DEVELOPMENT PROJECT APPLICATION FORM

Project Name: Village of Pemberton Daycare

- A0.0 COVER PAGE
- A0.1 CONSTRUCTION ASSEMBLIES, ROOF PLAN
- A0.2 CODE REVIEW
- A0.3 SITE PLAN
- A0.4 SERVICES PLAN
- A1.0 OVERALL FLOOR PLAN
- A1.1 AREA PLAN
- A1.2 WINDOW & DOOR LEGENDS
- A2.0 OVERALL CRAWL SPACE PLAN
- A3.0 EXTERIOR ELEVATIONS
- A4.0 BUILDING CROSS SECTIONS
- A4.1 BUILDING WALL SECTIONS
- A4.2 STAIR & RAMP DETAILS
- A8.0 OVERALL RCP

PROJECT TITLE: VILLAGE OF PEMBERTON 7396B COTTONWOOD STREET DAYCARE		P22973	As indicated
DRAWING TITLE: CONSTRUCTION ASSEMBLIES, ROOF PLAN		DRAWN BY: RMM	DATE: 26 MAY 2023
		A0.1

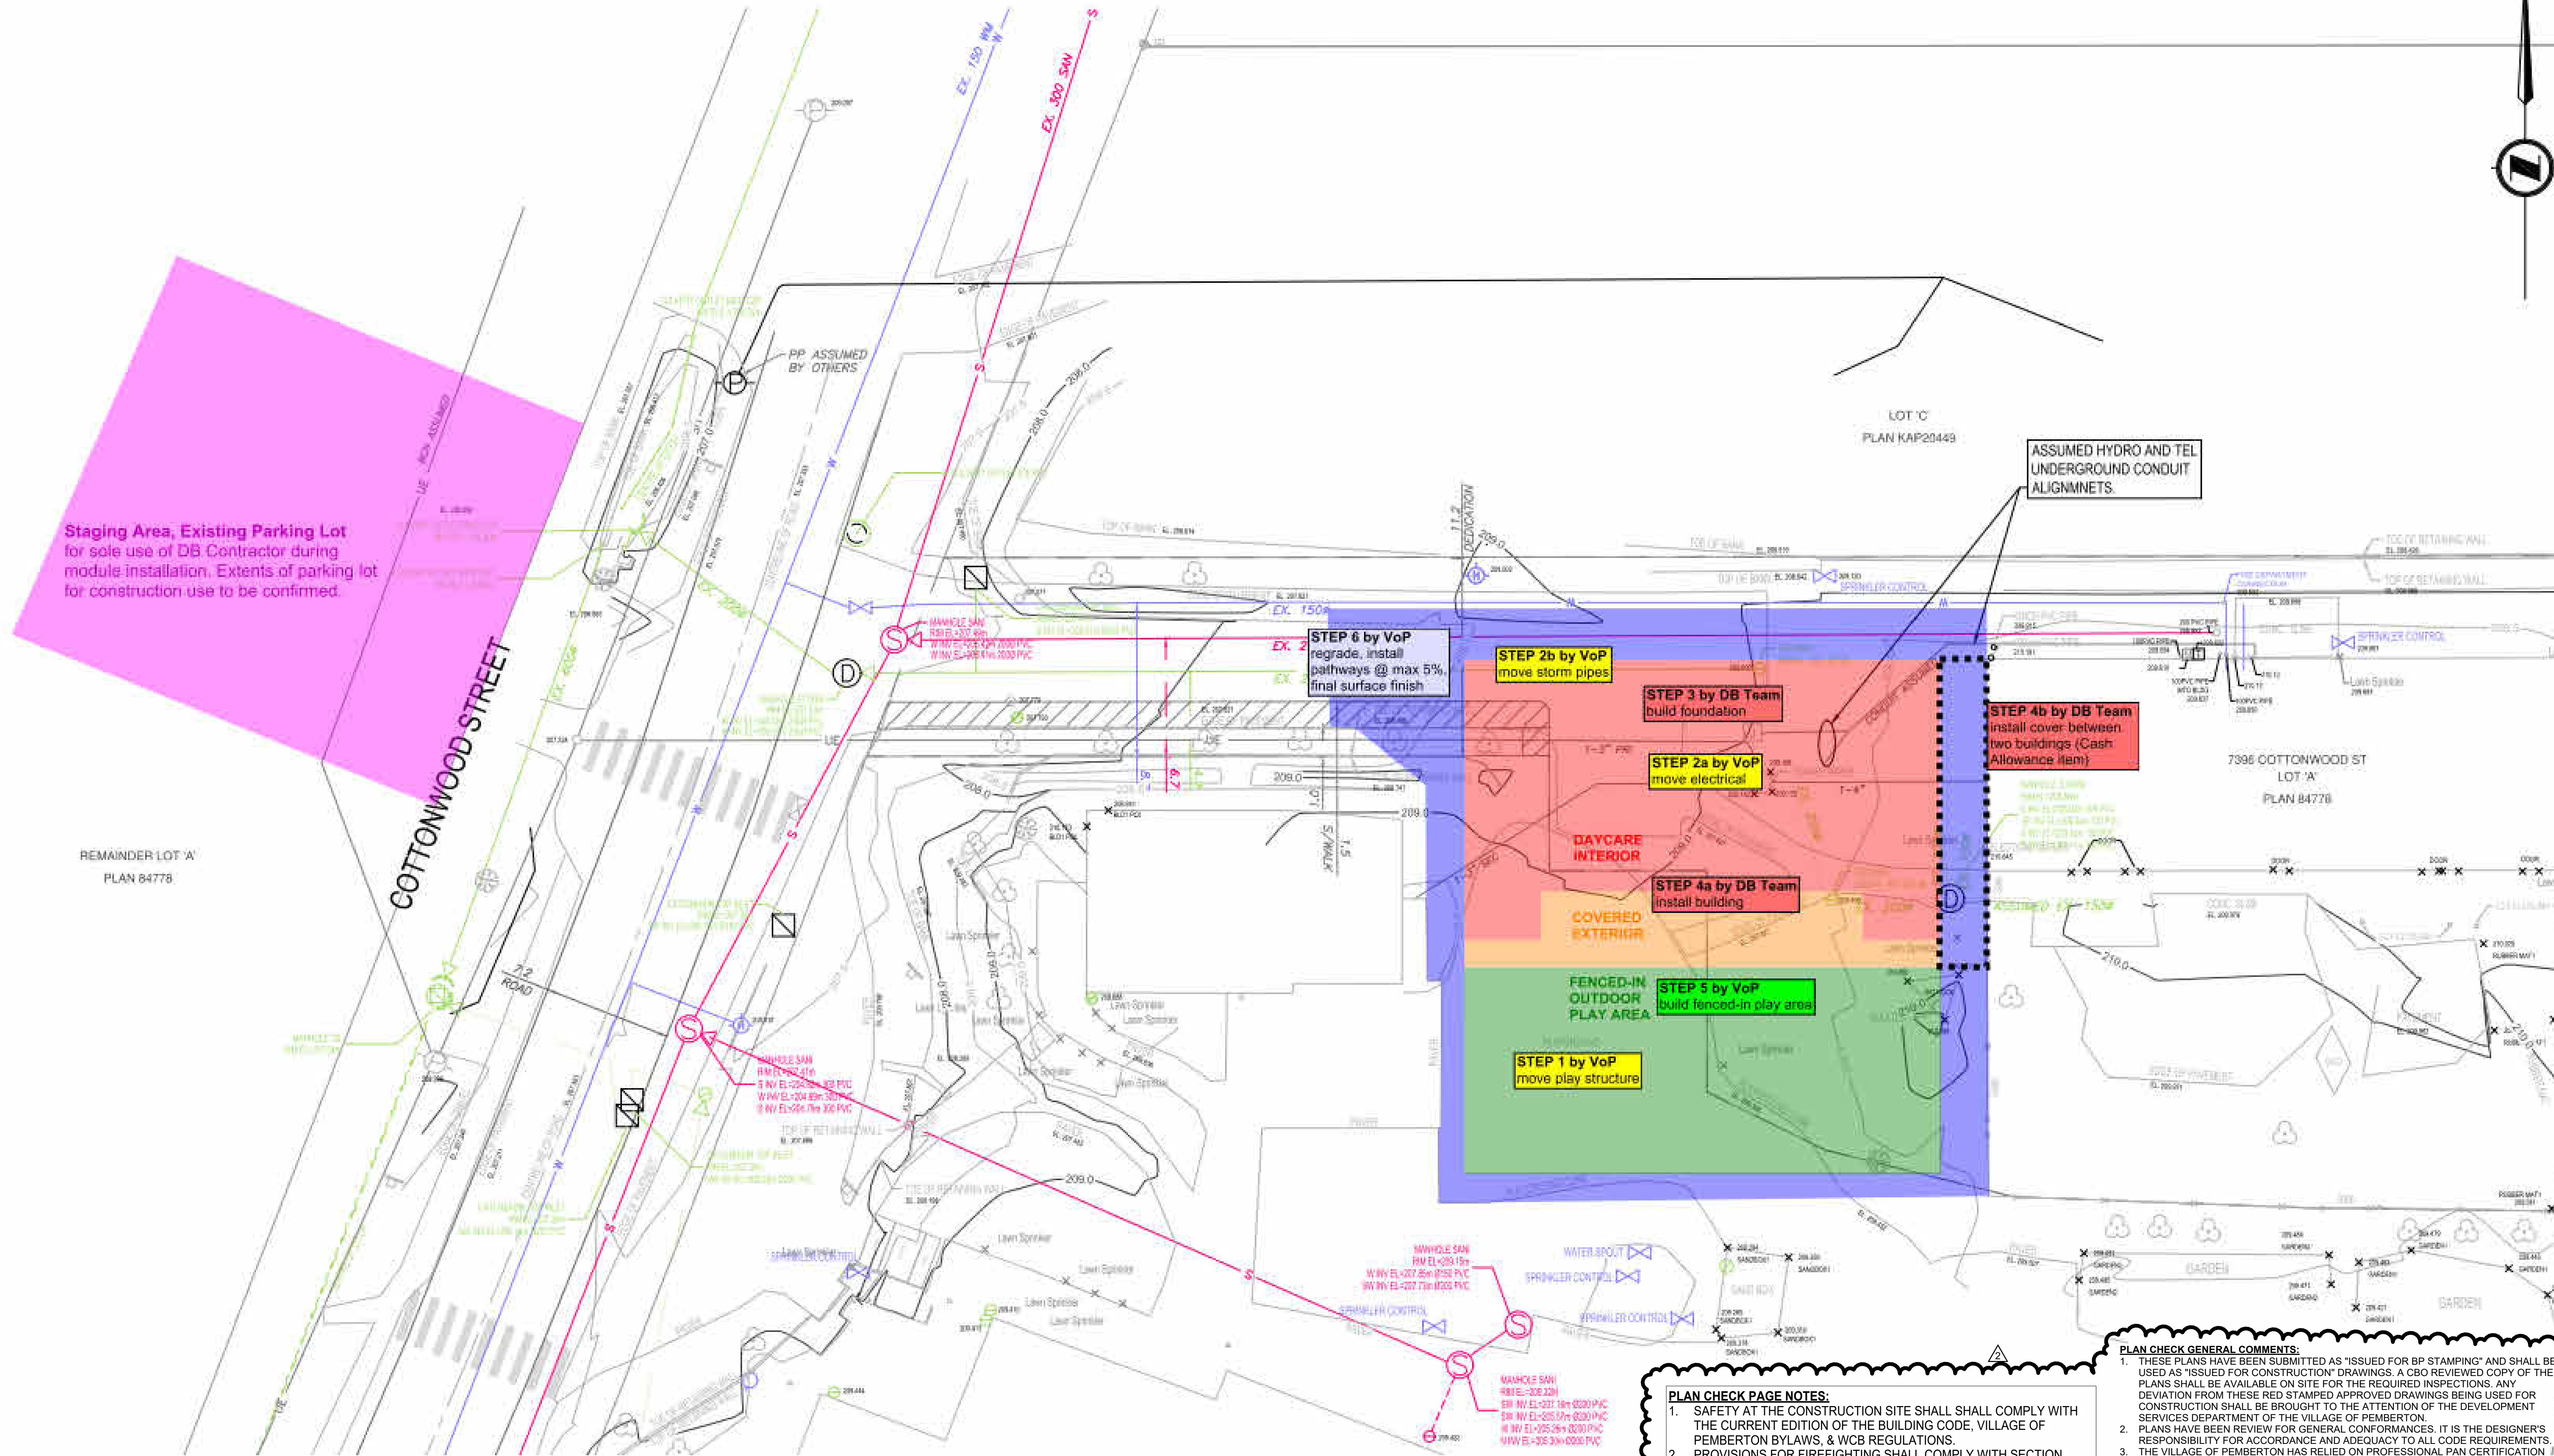
PLAN CHECK PAGE NOTES:
 1. SAFETY AT THE CONSTRUCTION SITE SHALL COMPLY WITH THE CURRENT EDITION OF THE BUILDING CODE, VILLAGE OF PEMBERTON BYLAWS, & WCB REGULATIONS.
 2. PROVISIONS FOR FIREFIGHTING SHALL COMPLY WITH SECTION 3.2.5., DIVISION B, BCBC 2018.

1 ARCHITECTURAL PLAN - MAIN FLOOR BP
SCALE: 1/4" = 1'-0"

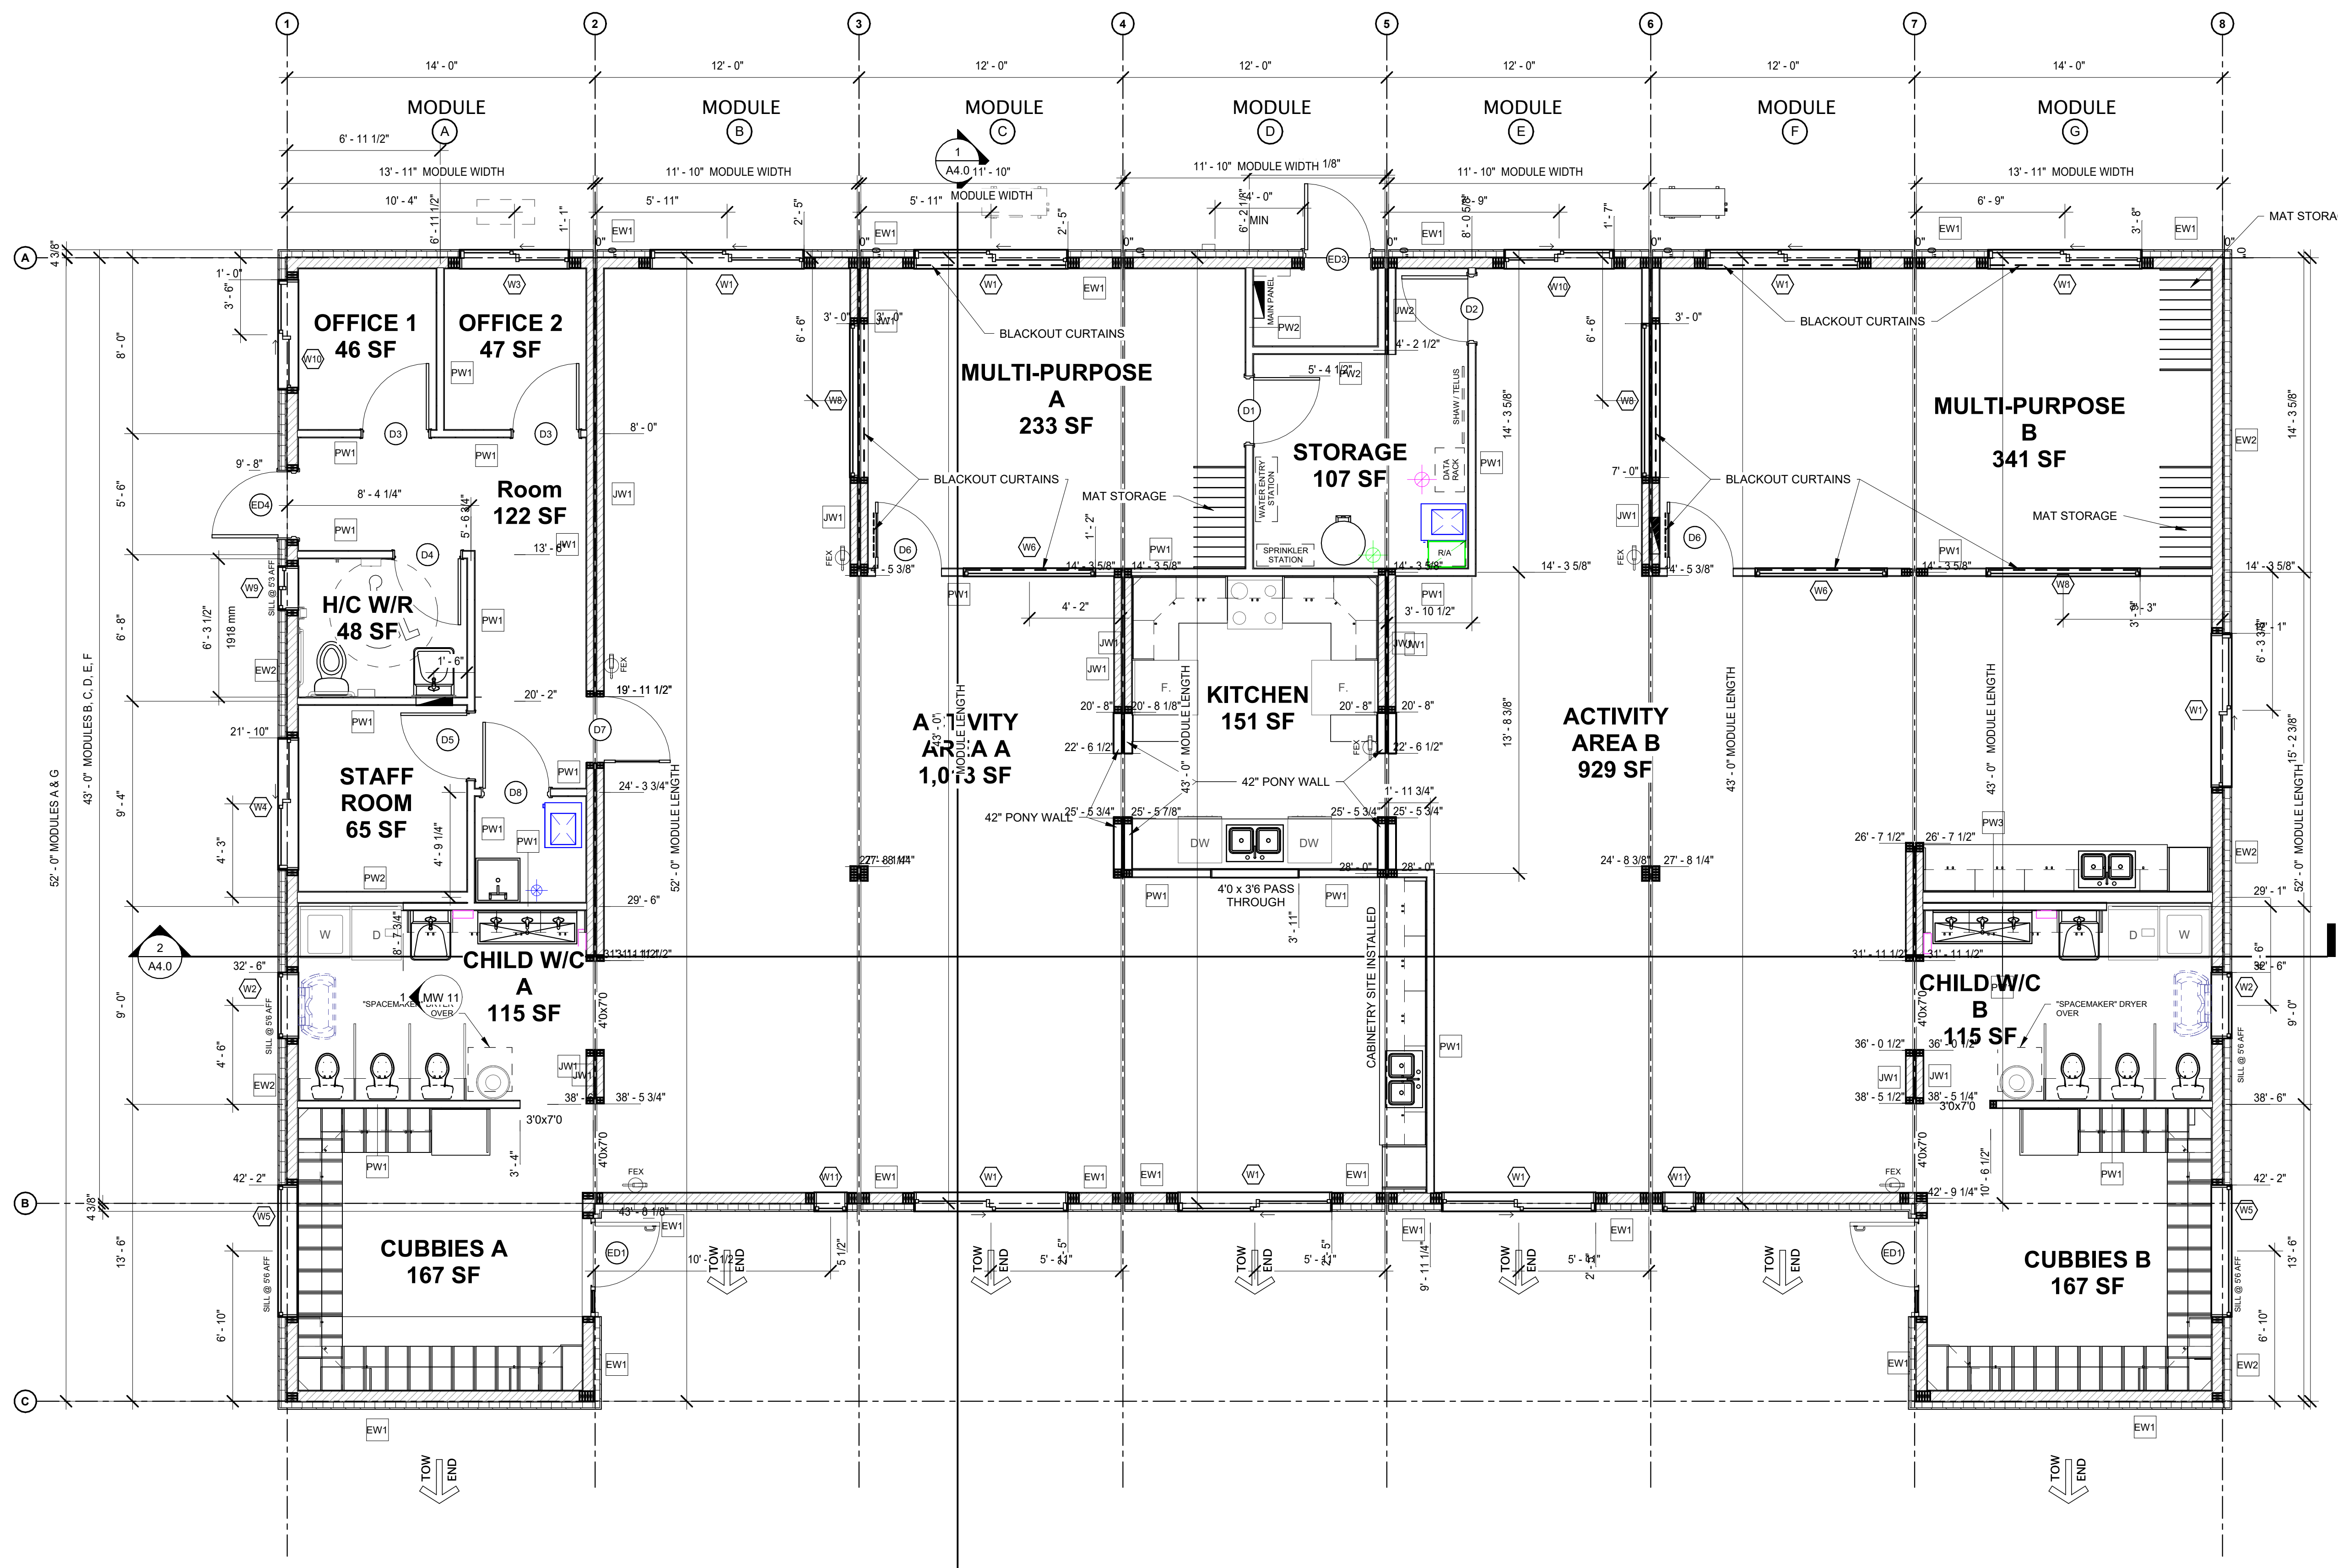
- PLAN CHECK PAGE NOTES:**
1. BUILDING ACCESSIBILITY INCLUDING STAIRS, RAMPS, LANDINGS, HANDRAILS AND GUARDS SHALL COMPLY WITH SECTION 3.8., DIVISION B, BCBC 2018 & THE BUILDING ACCESSIBILITY HANDBOOK 2020 (ILLUSTRATED COMMENTARY ON ACCESSIBILITY REQUIREMENTS).
 2. SMOKE / CO ALARMS SHALL BE INTERCONNECTED, HARDWIRED, AND CONNECTED TO THE FIRE ALARM SYSTEM.
 3. FIRE EXTINGUISHERS SHALL BE INSTALLED IN ACCORDANCE WITH NFPA 10.
 4. ADDITIONAL APPROVAL REQUIRED FOR ANY COMMERCIAL KITCHEN OPERATIONS IN THIS BUILDING. KITCHEN STOVE MAY BE USED FOR NON-GREASE LADEN VAPOURS, FOOD PREPARATION, AND FOR RE-HEATING FOOD ONLY. REQUIRED EXHAUST FAN VENTED TO THE OUTDOORS.
